**CITY PLAN COMMISSION****THURSDAY, January 15, 2026****FILE NUMBER:** PLAT-25-000180**SENIOR PLANNER:** Hema Sharma**LOCATION:** Lyndon B. Johnson Freeway/Interstate Highway No. 635 at Hillcrest Road, southeast corner**DATE FILED:** December 19, 2025**ZONING:** NO(A)**CITY COUNCIL DISTRICT:** 11**SIZE OF REQUEST:** 9.967-acres**APPLICANT/OWNER:** C&H Acquisitions, LLC**REQUEST:** An application to replat a 9.967-acre tract of land containing portion of City Block A/7467 to create one lot on property located on Lyndon B. Johnson Freeway/Interstate Highway No. 635 at Hillcrest Road, southeast corner.**SUBDIVISION HISTORY:** There has been no recent platting activity within close proximity to this request.**STAFF RECOMMENDATION:** The request complies with the requirements of the NO(A) Neighborhood Office District; therefore, staff recommends approval of the request subject to compliance with the following conditions:**General Conditions:**

PRELIMINARY PLAT  
HEB HILLCREST ADDITION  
LOT 1 BLOCK A (7117)

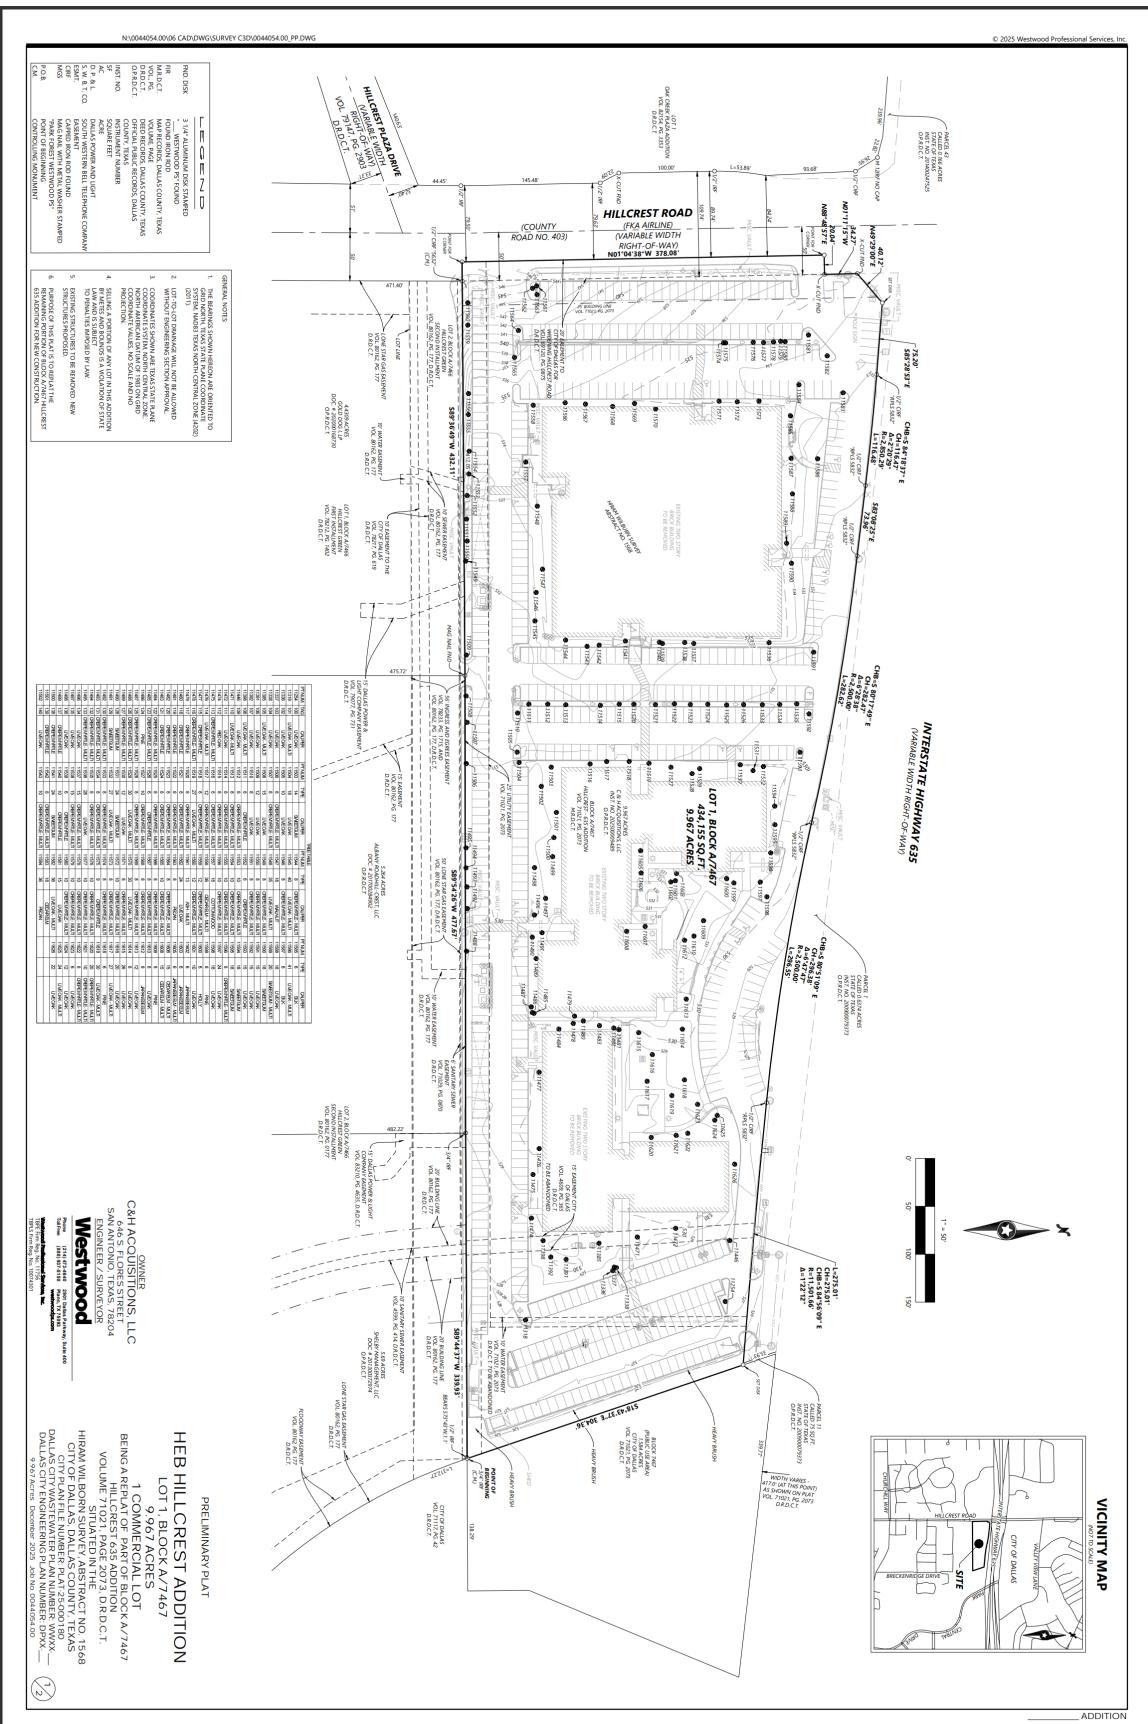
15. On the final plat, dedicate 50 feet of right-of-way (via fee simple) from the established center line of Hillcrest Road. *Section 51A 8.602(c)*
16. On the final plat, dedicate a minimum 20-foot by 20-foot corner clip (via fee simple or street easement) at the intersection of Hillcrest Road & Hillcrest Plaza. *Section 51A 8.602(d)(1)*

17. A larger corner clip may be requested during engineering plan and traffic review to accommodate an adequate turning radius, or to maintain public/traffic appurtenances, within the area of the corner clip. *Section 51A 8.602(d)(1), 51A 8.608(a)*

21. On the final plat, show how all adjoining right-of-way was created. Section 51A-8.403(a)(1)(A)(xxii).
22. On the final plat, show recording information on all existing easements within 150 feet of the property.
23. On the final plat, show all additions or tracts of land within 150 feet of the property with recording information. Platting Guidelines.

24. Additional design information is required for assessment. Site plan must be submitted showing proposed development, building finished floor elevation, development, existing mains – including downstream manhole, and proposed water and wastewater service locations. Submit water/wastewater engineering plans to 320 E. Jefferson Blvd., Room 200, Attention: Water and Wastewater Engineering.
25. Water and Wastewater main improvements is required by Private Development Contract. Submit water/wastewater engineering plans to 320 E. Jefferson Blvd., Room 200, Attention: Water and Wastewater Engineering.
26. Existing and any proposed Water and Wastewater Easements must be shown and/or increased to conform to current design standards. **Notice:** Minimum DWU easement size 20' for one utility and 25' for both water and sewer. Larger diameter or deeper mains may require additional width.

27. Additional design information needed to complete review. Provide a brief description of the proposed project and a copy of the site plan to daniel.silva1@dallas.gov to determine street lighting requirements.
28. Prior to the final plat, Contact Real Estate to process 15 easement and 10 water easement abandonments. Please show each abandonment on the plat as follows: Abandonment authorized by Ordinance No. \_\_\_\_\_, recorded as Inst. No. \_\_\_\_\_.
29. On the final plat, change "Interstate Highway 635" to "Lyndon B. Johnson Freeway/Interstate Highway No. 635". Section 51A-8.403(a)(1)(A)(xii).
30. On the final plat, change "Hillcrest Road (FKA Airline)" to "Hillcrest Road (FKA Airline Road)". Section 51A-8.403(a)(1)(A)(xii).
31. On the final plat, identify the property as Lot 1 in City Block A/7467.
